January 10, 1978

Docket Nos. 50-259
50-260
and 50-296

Tennessee Valley Authority
ATTN: Mr. Godwin Williams, Jr.
Manager of Power
818 Power Building
Chattanooga, Tennessee 37201

Amendment No. 35 to DPR-33 changes the Technical Specifications to incorporate the limiting conditions for operation associated with Cycle 2 operation of Browns Ferry Nuclear Plant, Unit 1. These changes involve a revised fuel cladding integrity safety limit for minimum critical power ratio (MCPR), revised operating limit MCPR's for both 7x7 and 8x8 fuel assemblies, the addition of linear heat generation rate (LHGR) limits for the 8x8 fuel, revised limits for the maximum average planar linear heat generation rate (MAPLHGR) for the 7x7 and 8x8 fuel assemblies, and reduced limits for scram insertion times. The revised limits for the MAPLHGR result from your reanalysis of the Emergency Core Cooling System performance in response to the Commission's Order of March 11, 1977. We have found your reanalysis to be acceptable. Effective upon issuance of this amendment, the Commission's Order for Modification of License dated March 11, 1977, relative to Facility Operating License No. DPR-33, is terminated. In additi

FIGURE 3.5.2

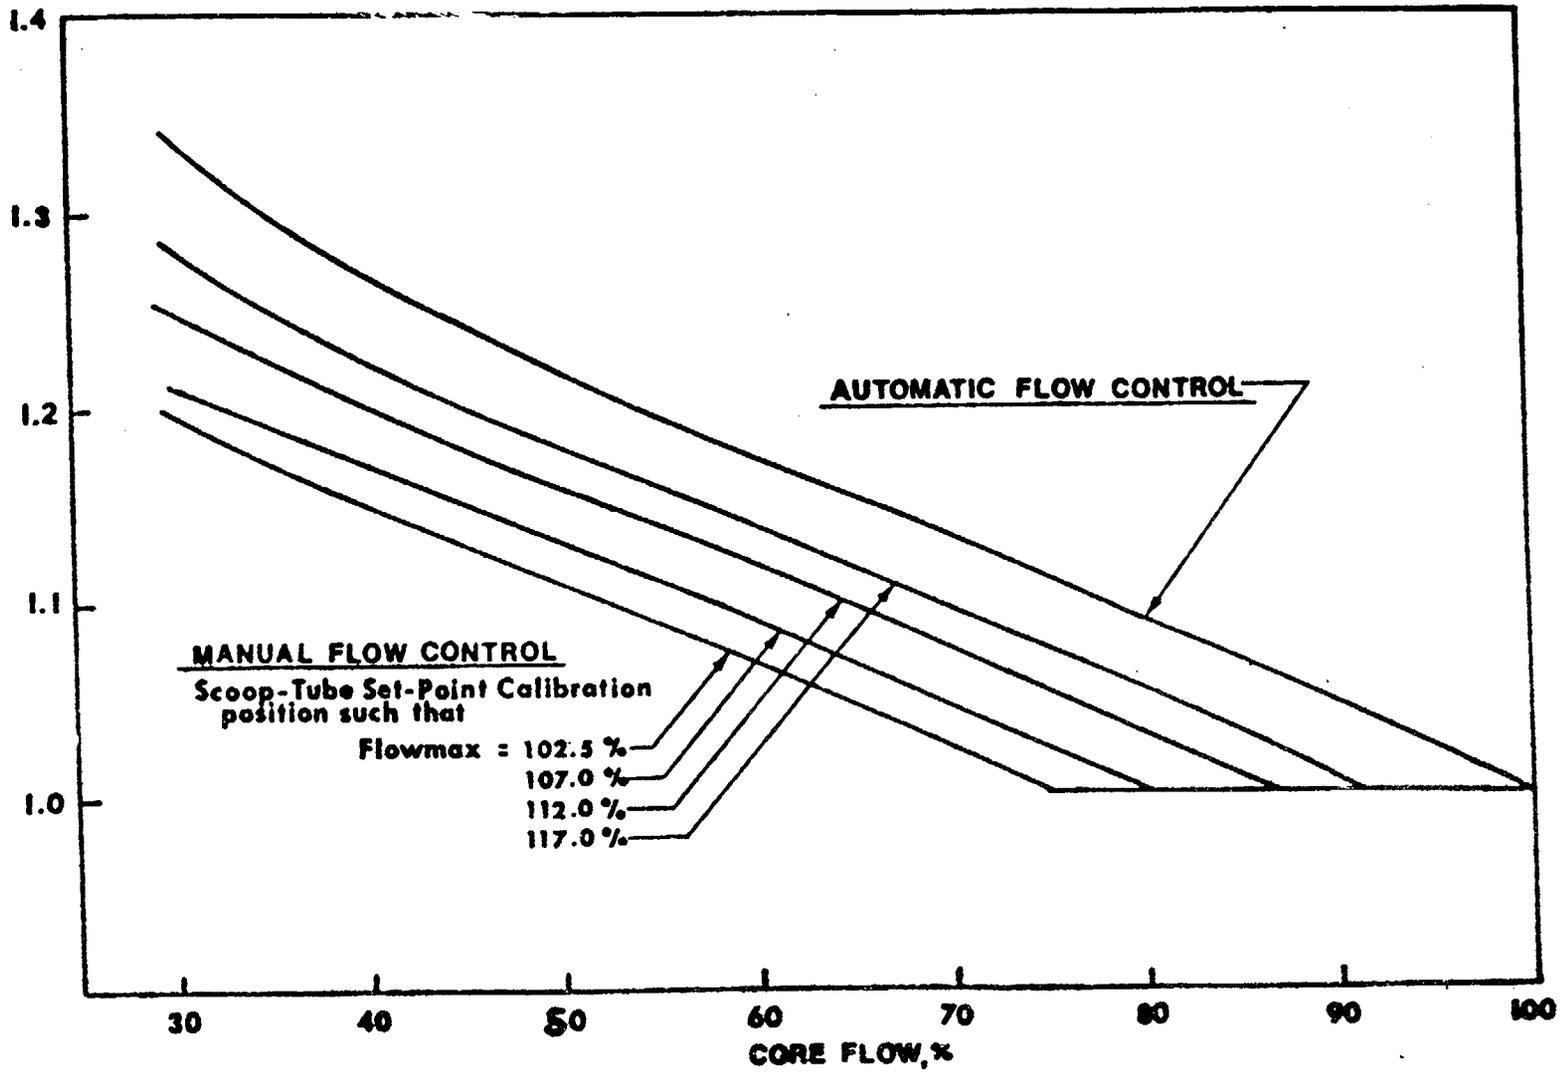
The MCPR operating limit for BFNP 1 is now dependent upon the average exposure for the core. The MCPR operating limit for the 7x7 fuel assemblies is in general different from that for the 8x8 assemblies. For steady state power operation the value for MCPR will be as shown in Figure 3.5.3. These values of MCPR are for operation at rated power and flow. For core flows other than rated the MCPR shall be greater than MCPR' times K_f , where MCPR' is the appropriate value from Figure 3.5.3 and K_f is as shown in Figure 3.5.2.

MCPR VS CYCLE AVERAGE EXPOSURE-----FIGURE 3.5.3

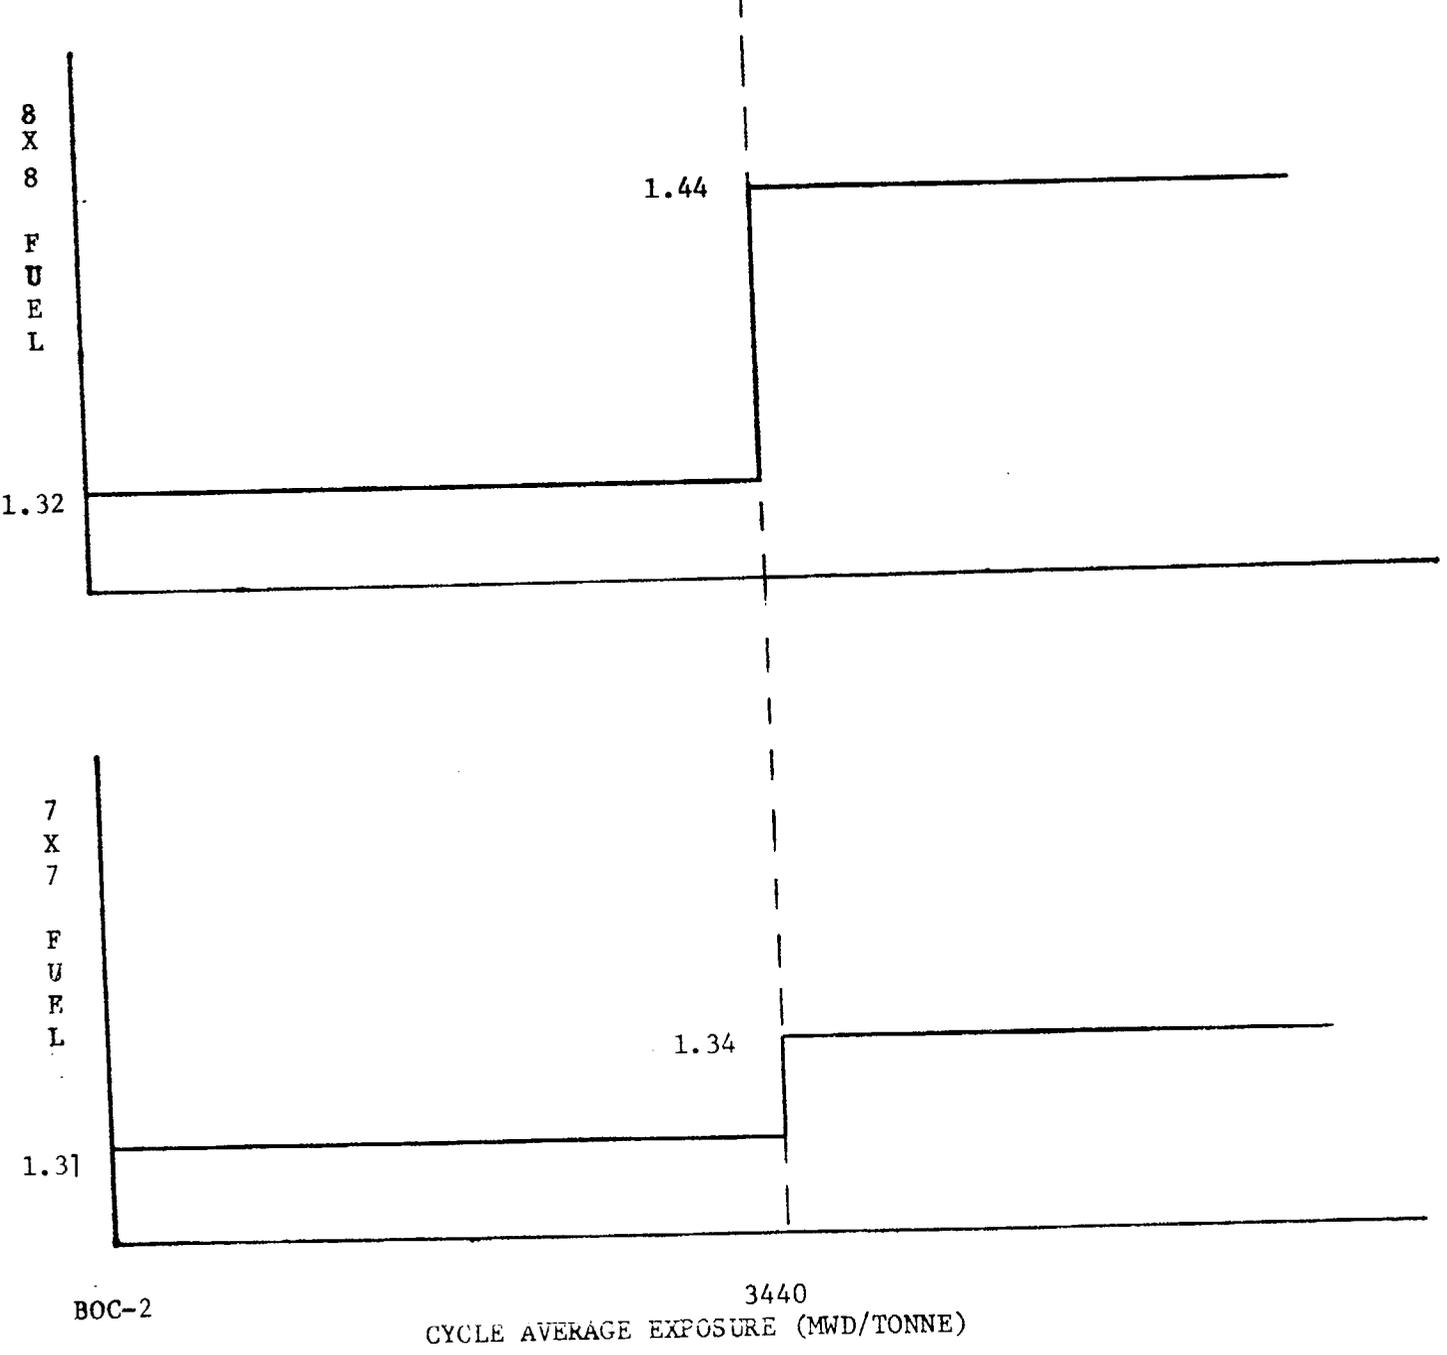
For analyses of the thermal consequences of the transients a MCPR given by figure 3.5.3 is conservatively assumed to exist prior to initiation of the transients.

Analyses of the limiting transients show that no scram adjustment is required to assure MCPR > 1.06 when the transient is initiated from MCPR $>$ the values shown in Figure 3.5.3.
